Windshield Wipers Chatter

(Supersedes 07-015, dated May 4, 2007; see Revision Summary)

REPLACEMENT PLASTIC BLADES

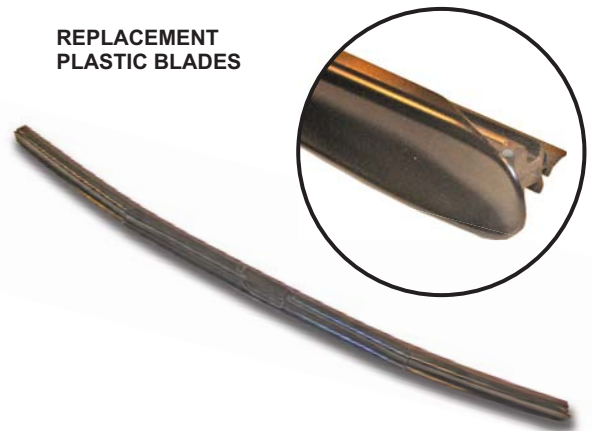
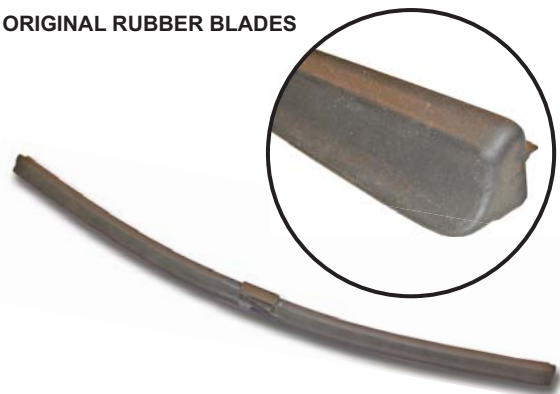
The windshield wiper blades chatter when used.

The blade pressure against the windshield is weak.

Replace the original windshield wiper blade assemblies with new plastic blade assemblies.

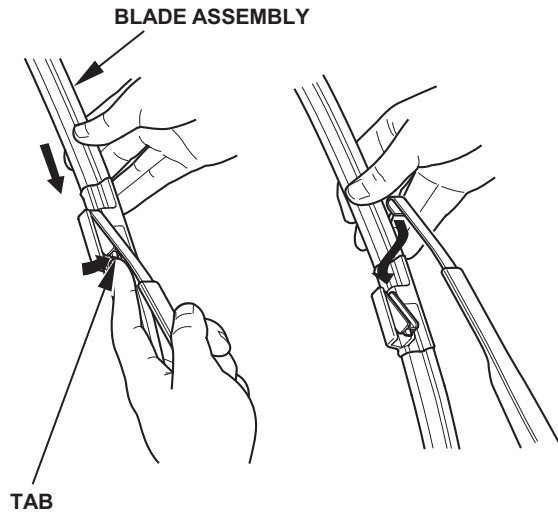
1. Pull up the wiper arms from the windshield.
2. Press and hold the lock tab, then slide the blade assembly toward the lock tab until it releases from the wiper arms.

3. Install the new wiper blade assemblies.
